## Product Change Notice (PCN)

PCN Number: **PCN-0420239R-01**

Product(s) Affected: **HSB40-252510P**

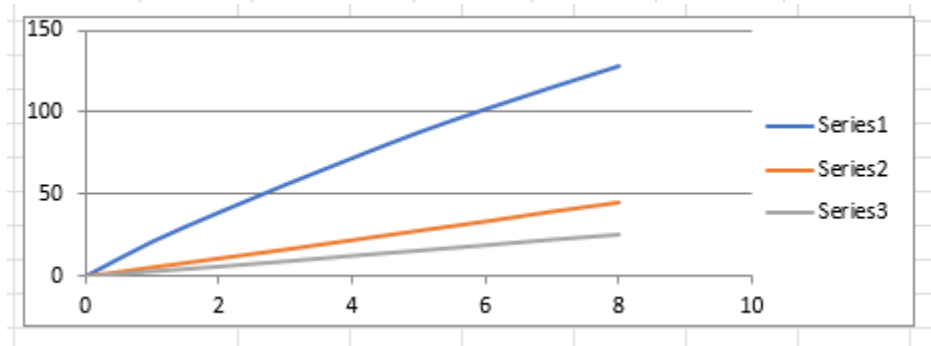
Description of Change: **3 cross-cut instead of 2. Drawing and thermal performance updates as shown below:**

Heatsink Temperature Rise Above			
Power (W)	Natural Conv.	200 LFM 1 m/s	400 LFM 2 m/s
0	0	0	0
1	21.2	5.6	3.1
2	39.1	11.0	6.0
3	56.1	16.4	9.1
4	72.3	22.1	12.4
5	88.1	27.8	15.5
6	102.3	33.4	18.7
7	115.7	39.4	22.0
8	128.6	44.9	25.0

MODEL	thermal resistance				power dissipation
	@ 75°C ΔT, nat conv (°C/W)	@ 1W, nat conv (°C/W)	@ 1W, 200 LFM (°C/W)	@ 1W, 400 LFM (°C/W)	@ 75°C ΔT, nat conv (W)
HSB40-252510P	18.04	21.2	5.6	3.1	4.16
